DEVELOPMENT REVIEW BOARD
SUPPLEMENTAL SUBMITTAL

PROJECT NO. PR-2020-004820

To: Jolene Wolfley and DRB Members, City of Albuquerque
From: Michael Vos, AICP, Consensus Planning, Inc.
Date: April 15, 2021
Re: Hotel Circle Ramada Apartment Conversion DRB Update (PR-2020-004820)

This memo provides updates on the proposed apartment conversion based on the comments received at the March 31, 2021 DRB meeting. The comments are numbered, and responses are in bold italics.

Exhibit – Building Encroachments Photos Attachment

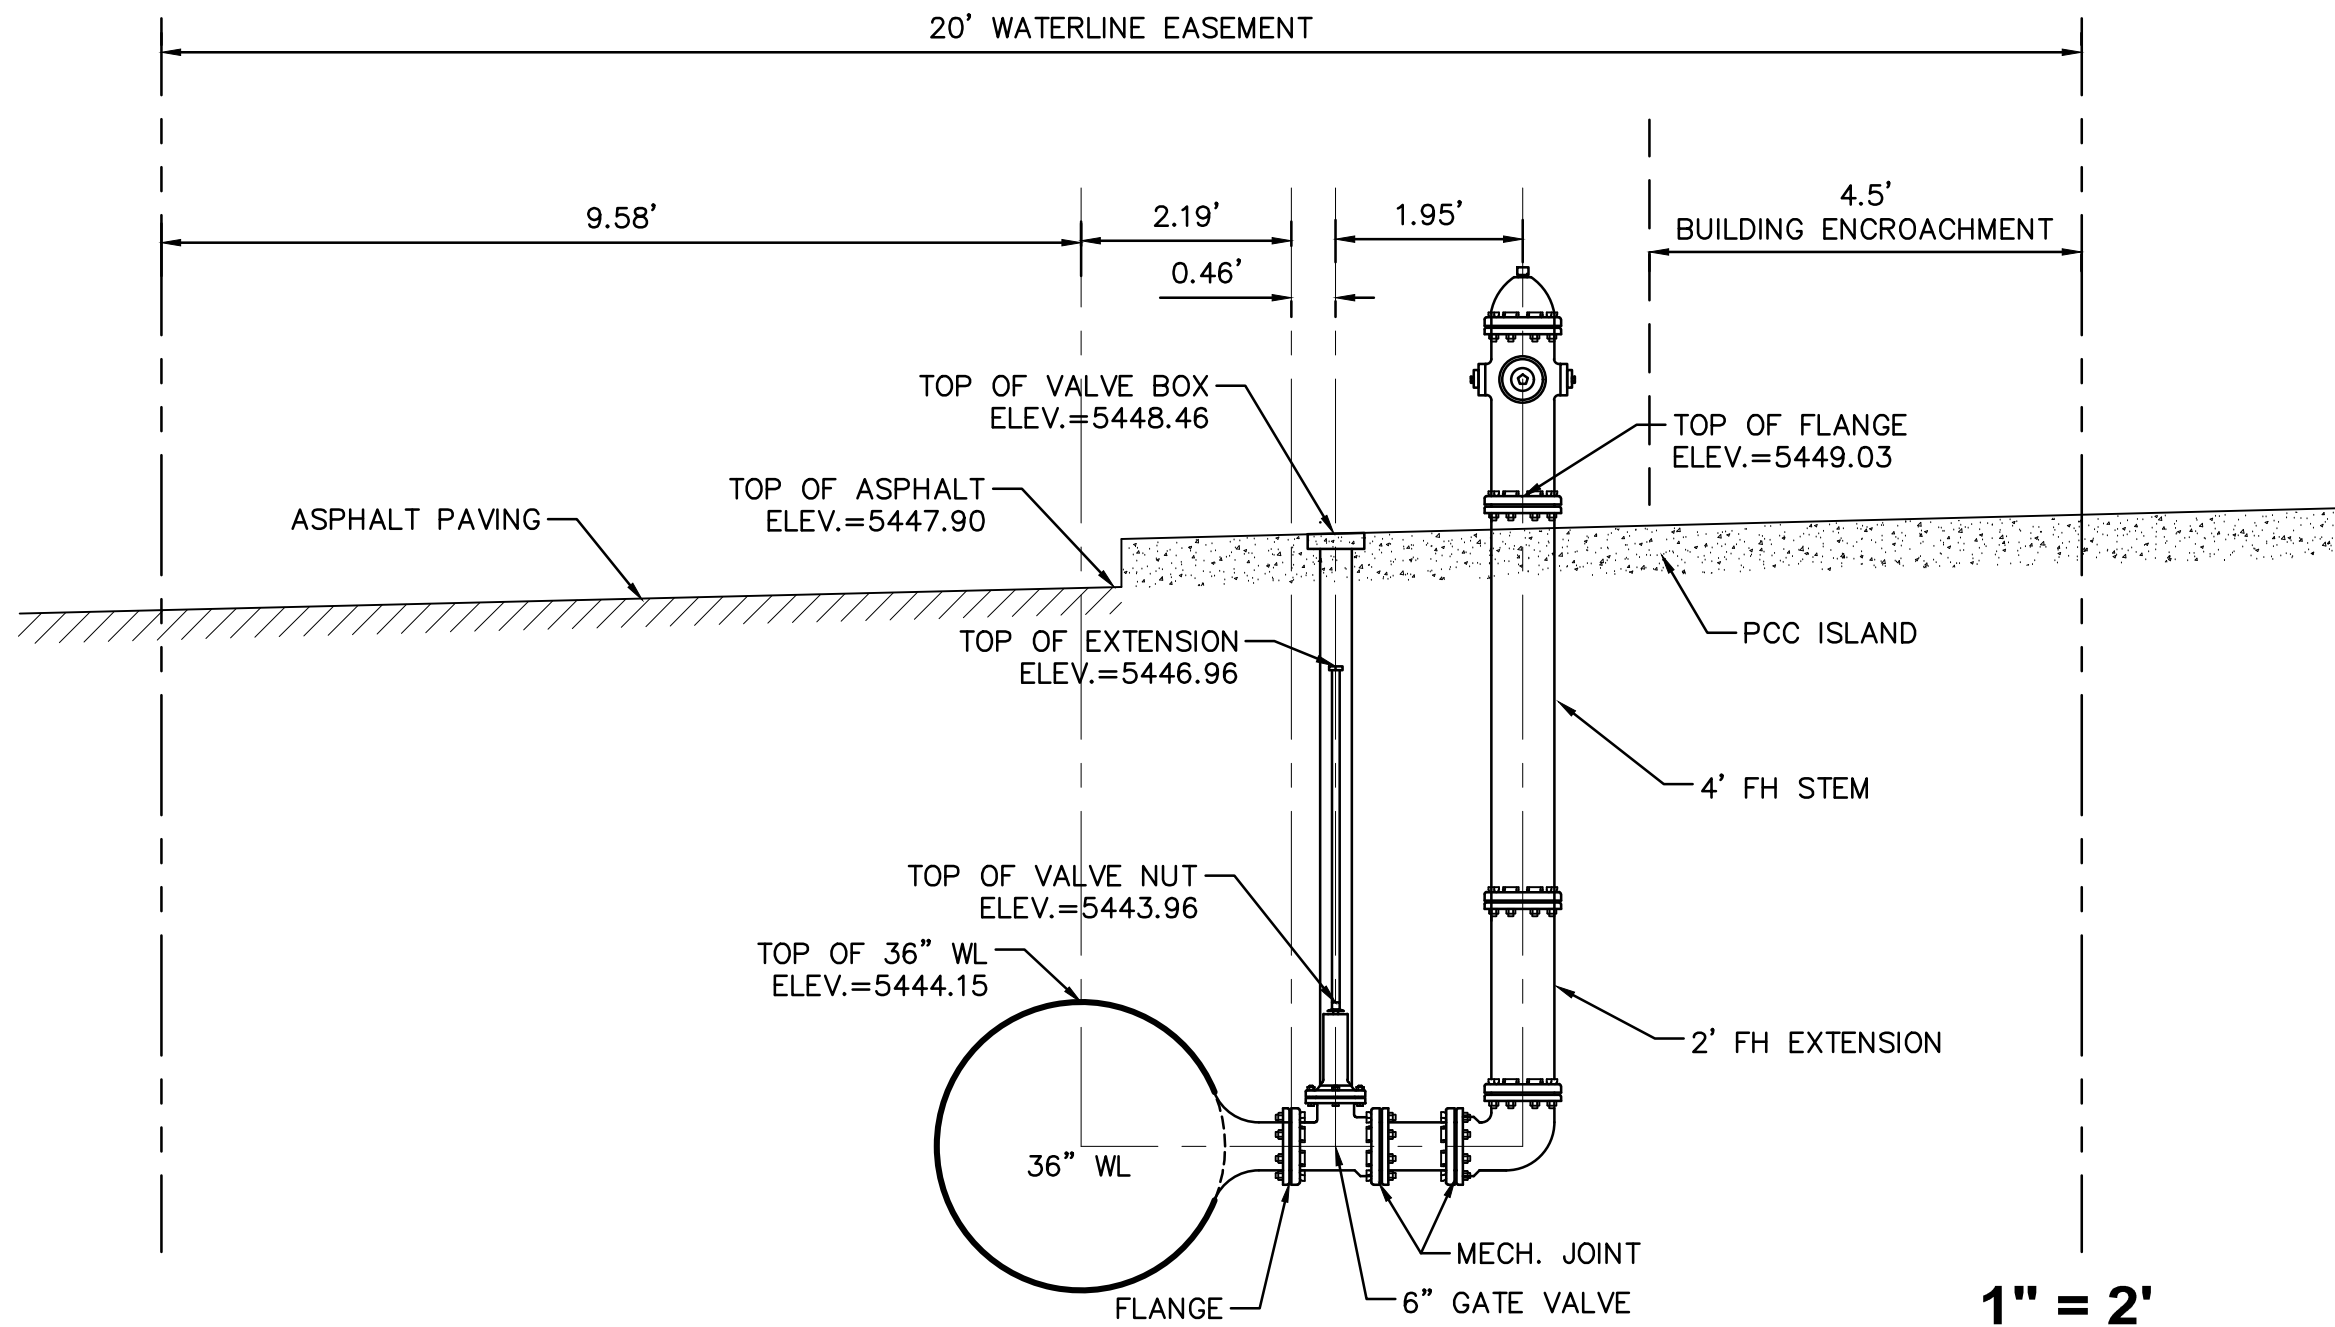
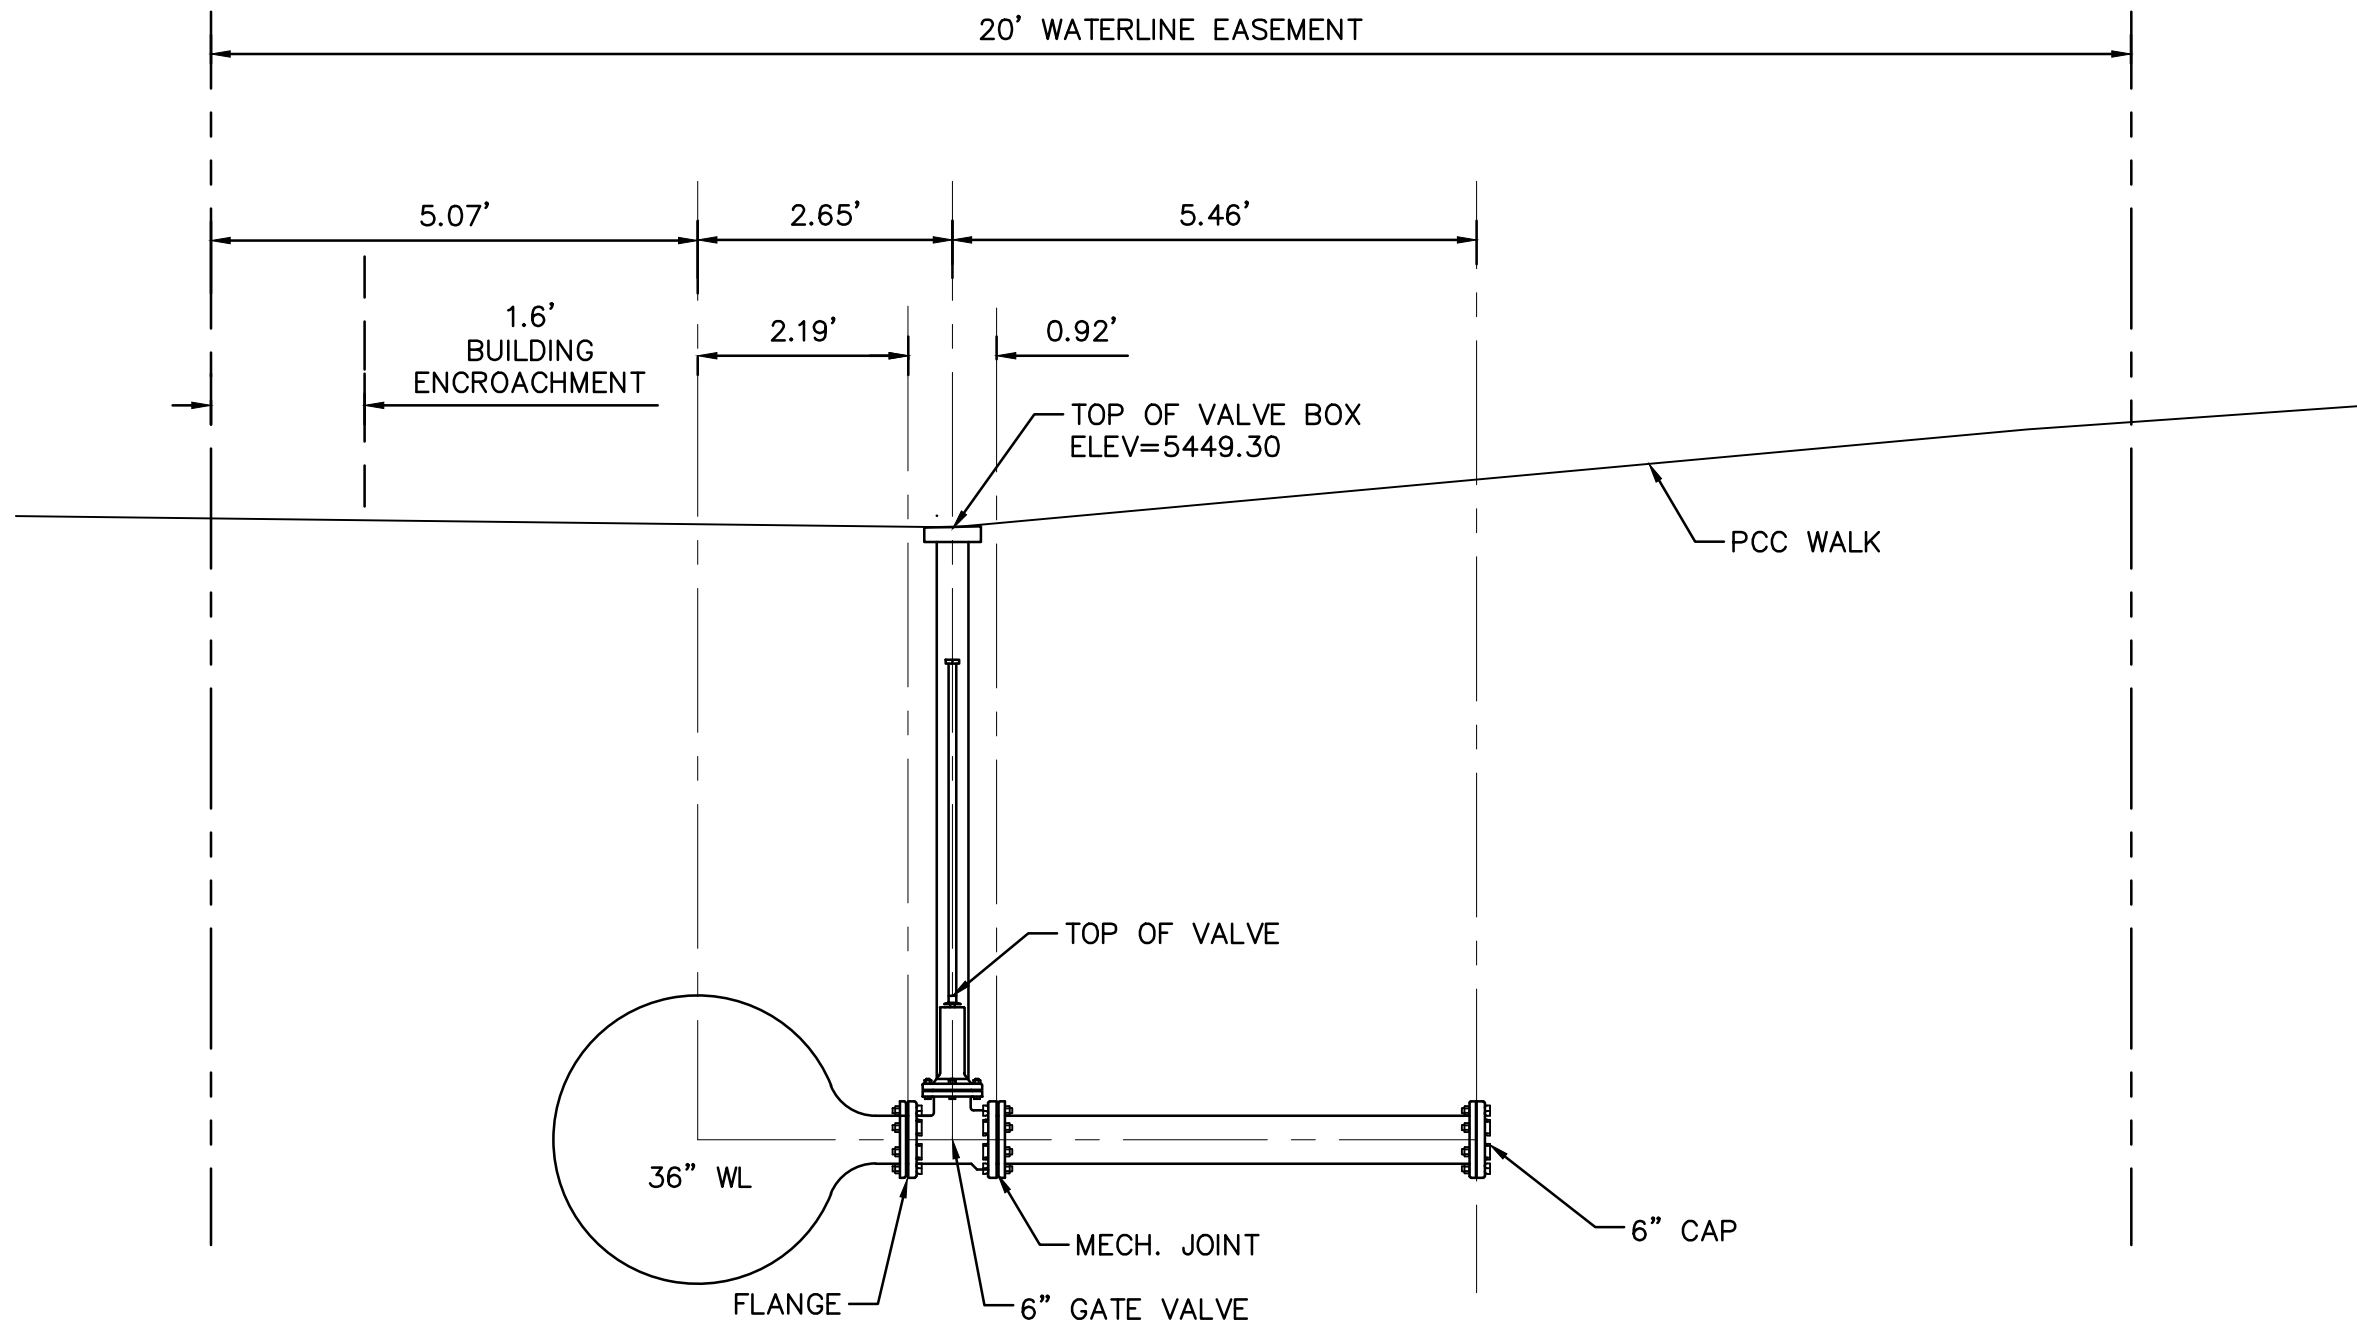
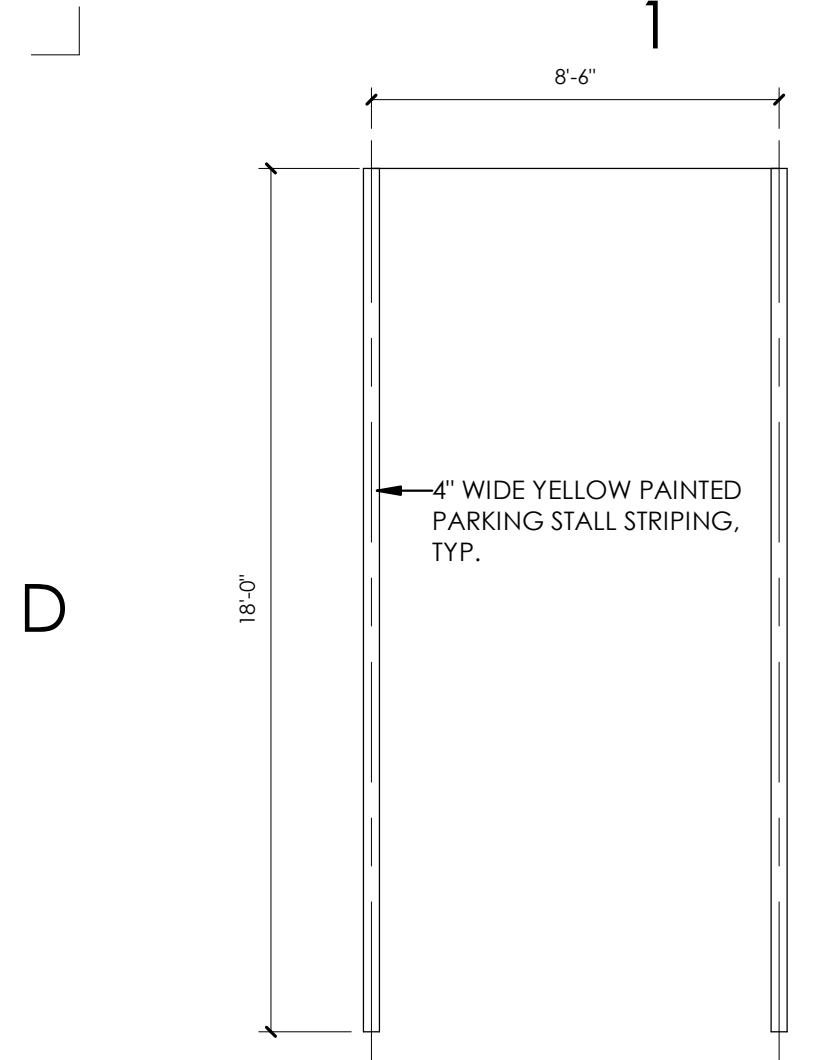
2. The Building #6 and southeast building exhibit on the encroachment and additional easement have been received. This will be reviewed with ABCWUA Legal and Water Operations. An encroachment notice is possibly needed regardless of the additional easement.

- a. ***We received further comment from Blain Carter via email regarding the encroachments and relationship between the easements on site and the proposed landscape plan. We have updated the landscape plan to relocate the trees within the courtyard out of the waterline easement and eliminate the trees that were proposed in the perimeter sewer easement at the south side of the site. The existing fence that is within the courtyard is not shown on the plan as it will be removed by this redevelopment. The only remaining encroachments are two existing trees and the buildings that have previously been discussed. The Applicant requests specific direction from the Water Authority regarding what is required regarding these longstanding site features that encroach in the easement, other than the previously discussed additional easement and notice of encroachment. Attached are additional exhibits prepared by the Civil Engineer, Isaacson & Arfman, regarding the location of the existing waterline and building encroachments.***

B2 SITE - ADA CURB RAMP LOCATION 1
1/4" = 1'-0"

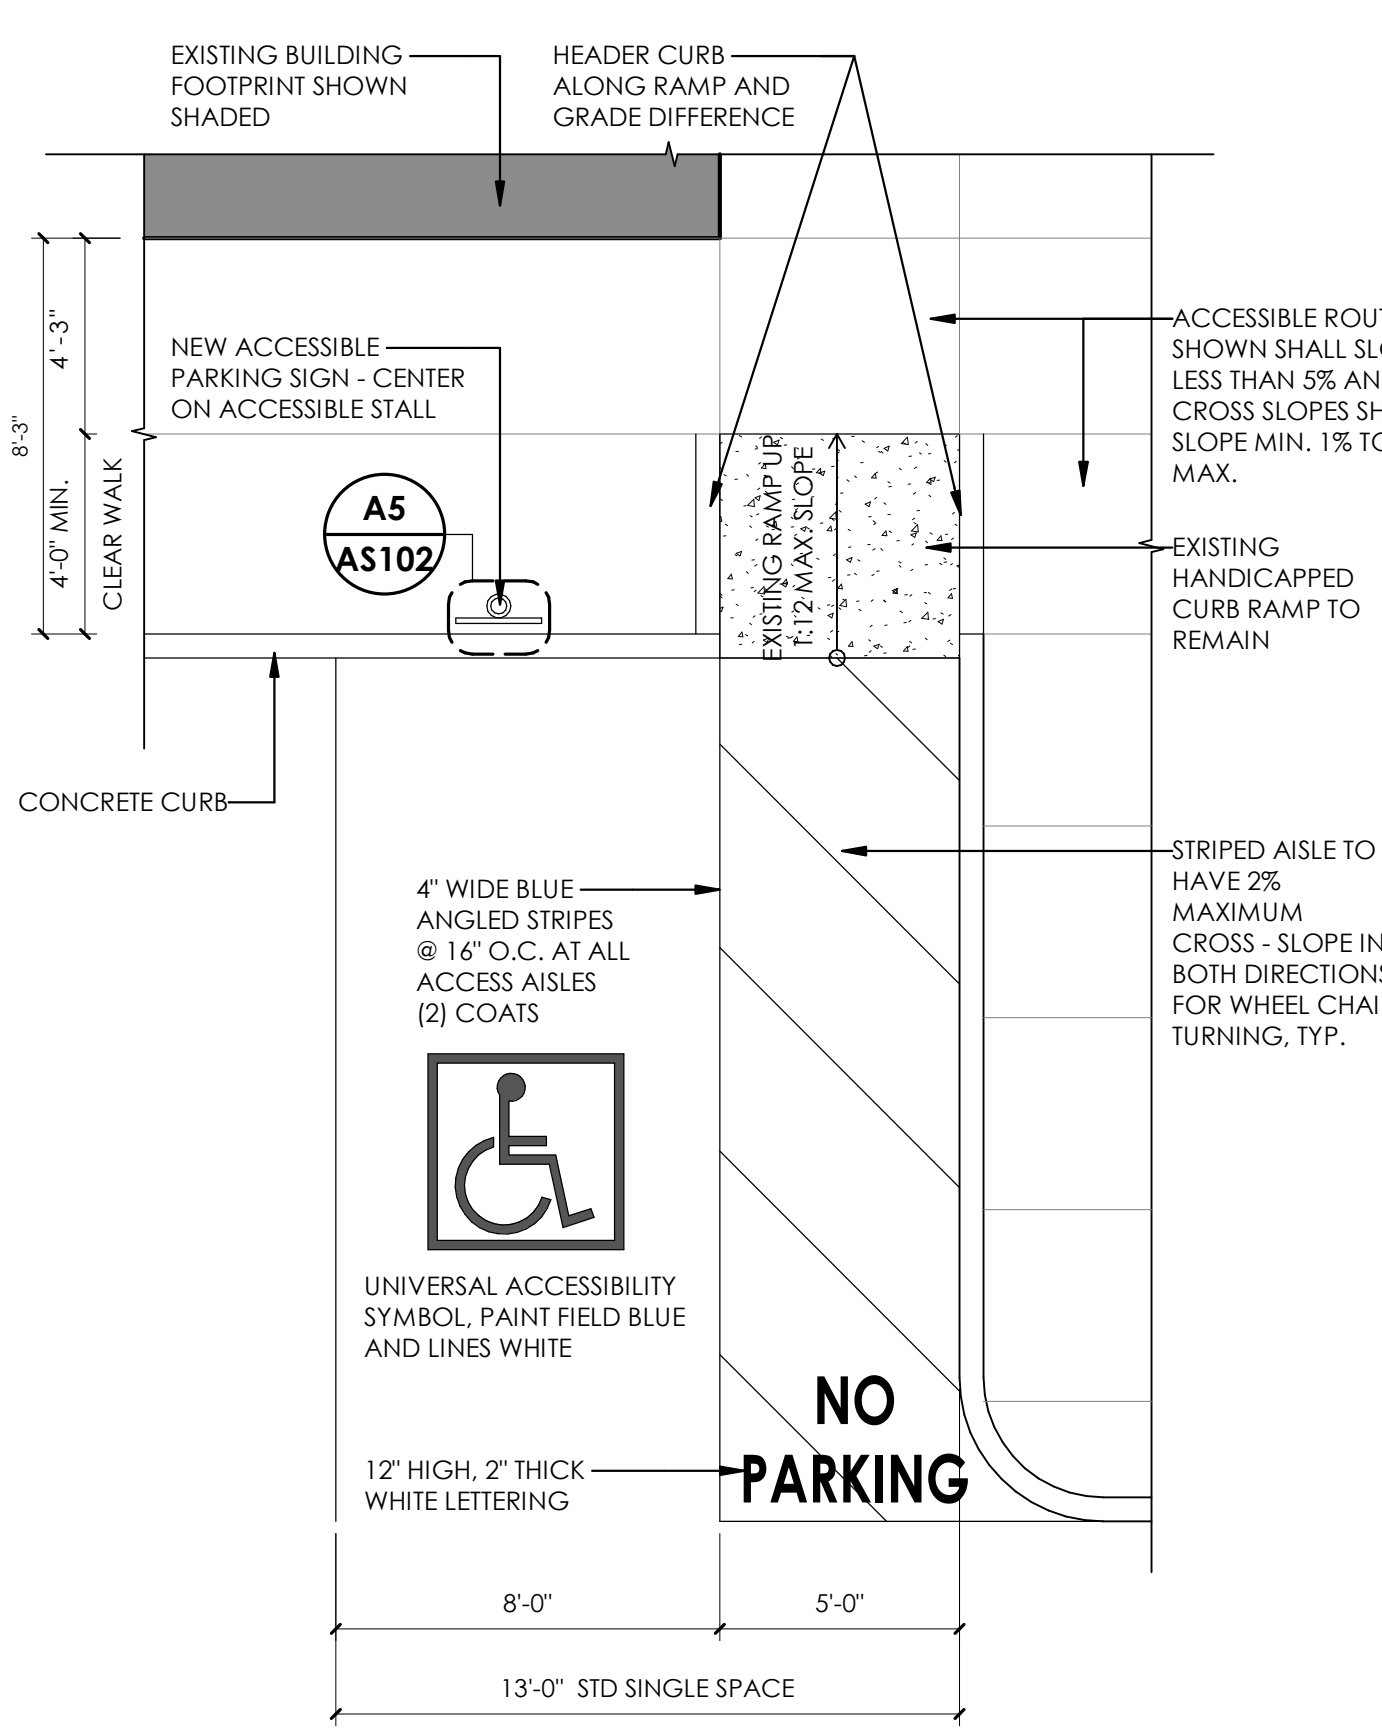
- a. Detail updated.**
6. At B4/103, at the bottom of the ramp that is parallel to the aisle should have 2% maximum cross-slope labeled in both directions for wheelchair turning. Same applies for B2.

- a. Detail updated.**

B4 SITE - ADA CURB RAMP LOCATION 2 - RE-STRIPE @ EXISTING RAMP
1/4" = 1'-0"

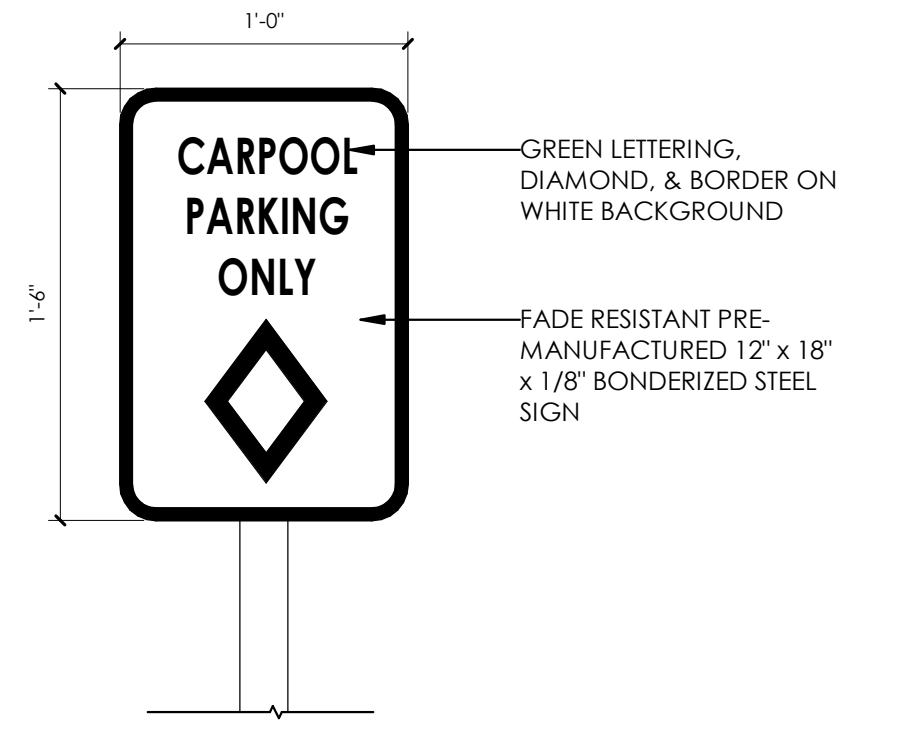
- a. The parking spaces were clarified to identify all 8 required spaces more clearly.**
4. There is a B4 in the details but not on the site plan.
 - a. The detail reference for the ADA space on the east side of the site has been updated to correctly reflect this detail.**

5. At A1/103, there needs to be header curb labeled where there is a grade difference in the sidewalk alongside the ramp. This also applies to detail B4.
